UNITED STATES PATENT AND TRADEMARK OFFICE

10/594,561

Kazumasa Tanida

Office Action Summary	Application No. 10/594,561	Applicant(s) TANIDA ET AL.	
	Examiner TERESA M. ARROYO	Art Unit 2826

Fig.2

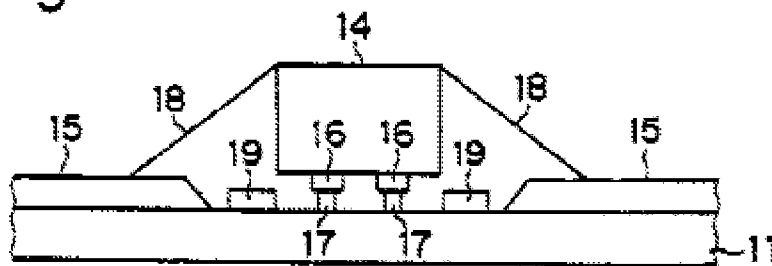
Regarding claim 16, Seko discloses A semiconductor device, comprising:

a solid state device 11 having a surface (top) and an external connection surface (bottom) which is a surface on a side opposite the surface (top),

a semiconductor chip 14 having a functional surface (bottom),

a connecting member 16 provided between the surface (top) of the solid state device 11 and the functional surface (bottom) of the semiconductor chip 14, the connecting member 16 extending over a distance between the surface (top) of the solid

state device 11 and the functional surface (bottom) of the semiconductor chip 14 and having a constant width,

an insulating film 15 provided on the surface (top) of the solid state device 11, the insulating film 15 having an opening (unlabeled) greater in size than the semiconductor chip 14, and

a sealing layer 18 that completely seals the opening (unlabeled) and a space between (unlabeled) the solid state device 11 and the semiconductor chip 14.

Regarding claim 17, Seko discloses The semiconductor device according to claim 16, wherein a connection pad 17 is provided on the surface (top) of the solid state device 11.

Regarding claim 18, Seko discloses The semiconductor device according to claim 17, wherein the connecting member 16 includes the connection pad 17.

Regarding claim 19, Seko discloses The semiconductor device according to claim 17, wherein the solid state device 11 and the semiconductor chip 14 are bonded by means of the connecting member 16 including the connection pad 17 with a predetermined interval between the solid state device 11 and the semiconductor chip 14.

Regarding claim 20, Seko discloses The semiconductor device according to claim 16, wherein the solid state device 11 and the semiconductor chip 14 are electrically connected together.

Regarding claim 21, Seko discloses The semiconductor device according to claim 16, wherein the insulating film 15 is a solder resist film.

Regarding claim 22, Seko discloses The semiconductor device according to claim 16, wherein the insulating film 15 has a thickness smaller than an interval between the surface of the solid state device 11 and the semiconductor chip 14.

Regarding claim 23, Seko discloses The semiconductor device according to claim 16, wherein the opening (unlabeled) of the insulating film 15 is formed so that the semiconductor chip 14 completely falls laterally within the opening (unlabeled).

Regarding claim 25, Seko discloses The semiconductor device according to claim 16, wherein the sealing layer 18 is provided in such a manner as to fill the opening (unlabeled) with the sealing layer 18, and wherein the sealing layer 18 [serves to] seal a gap between the solid state device 11 and the semiconductor chip 14 and [to] protect the functional surface (bottom), the connecting member 16 and an exposed part of the surface (top) of the solid state device 11 exposed from the opening (unlabeled) of the insulating film 15. Note the terminology in brackets is functional language not being given any patentable weight.

Regarding claim 31, Seko discloses The semiconductor device according to claim 16, wherein the semiconductor chip 11 has the functional surface (bottom) only on one surface of the semiconductor chip 11.

Regarding claim 37, Seko discloses The semiconductor device according to claim 16, wherein no other wiring than a connection pad 17 for connection with the semiconductor chip 14 is provided on the solid state device 11 in the opening (unlabeled) of the insulating film 15.

FIG. 2

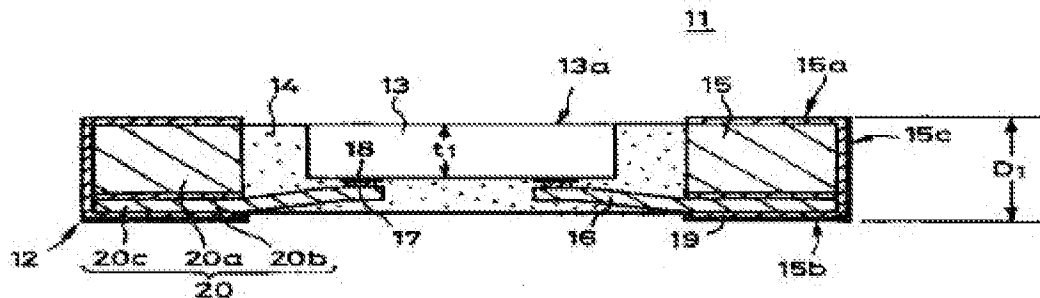
Regarding claim 26, Seko fails to disclose The semiconductor device according to claim 16, wherein an end electrode that is electrically connected to the connecting member is formed at an end of the solid state device.

Kojima et al. teach a semiconductor device including an end electrode 15c connected to a connecting member 18 formed at an end of a solid state device 15.

Therefore, it would have been obvious to a person of ordinary skill in the art at the time the invention was made to use an end electrode in Seko since they are well-known in the art to mount a package from any surface as taught by Kojima et al. in col. 5, lines 36-43.

Regarding claim 27, Kojima et al. teach The semiconductor device according to claim 26, wherein the end electrode 15c leads from the surface (top) to the external connection surface (bottom) via an end face on the solid state device 15.

Regarding claim 28, Kojima et al. teach The semiconductor device according to claim 26, wherein the semiconductor device 13 [can] establish an electric connection with other wiring board 29 (Fig. 6) in the end electrode 15c. Note terminology in brackets is indefinite as to whether the features following it are intended to be part of the claim.

FIG. 4A

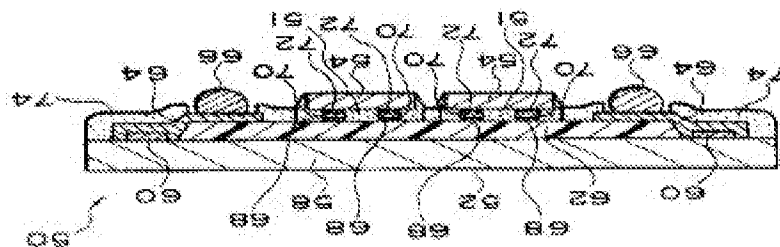
Regarding claim 29, Seko fails to disclose The semiconductor device according to claim 16, wherein the semiconductor chip includes two [or more] semiconductor chips each connected to the solid state device in a flip chip manner. Note terminology in brackets should be changed to at least two for clarity.

Hashimoto teaches a semiconductor device including two or more semiconductor chips 54 connected to a solid state device 58 in a flip chip manner.

Therefore, it would have been obvious to a person of ordinary skill in the art at the time the invention was made to use a plurality of chips in Seko since mere duplication of parts of an invention is of no patentable weight unless a new and useful

product results and since Hashimoto teaches two or more chips for a multi0chip module on a solid state device in col. 7, line 52 to col. 8, line 4.

Regarding claim 30, Hashimoto teaches The semiconductor device according to claim 29, wherein the opening (unlabeled) of the insulating film 74 includes two or more openings (openings) each completely laterally including each semiconductor chip 54.

FIG. 4 (d)

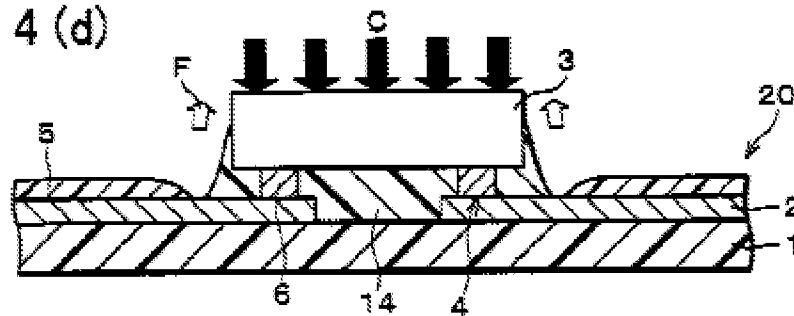
Regarding claim 33, Seko ('704) fails to disclose The semiconductor device according to claim 16, wherein the sealing layer is not on the insulating film.

Seko teaches a semiconductor device including a sealing layer 14 not on an insulating film 5.

Therefore, it would have been obvious to a person of ordinary skill in the art at the time the invention was made to provide a sealing layer not on an insulating film in Seko ('704) based on routine engineering design considerations as shown in Seko ('240).

Regarding claim 34, Seko ('240) teaches The semiconductor device according to claim 16, wherein the sealing layer 14 at least partially covers a side surface of the semiconductor chip 3.

Regarding claim 35, Seko ('240) teaches The semiconductor device according to claim 34, wherein the sealing layer 14 does not reach an upper surface of the semiconductor chip 3.

Regarding claim 36, Seko ('240) teaches The semiconductor device according to claim 35, wherein the sealing layer 14 is not on the insulating film 5.
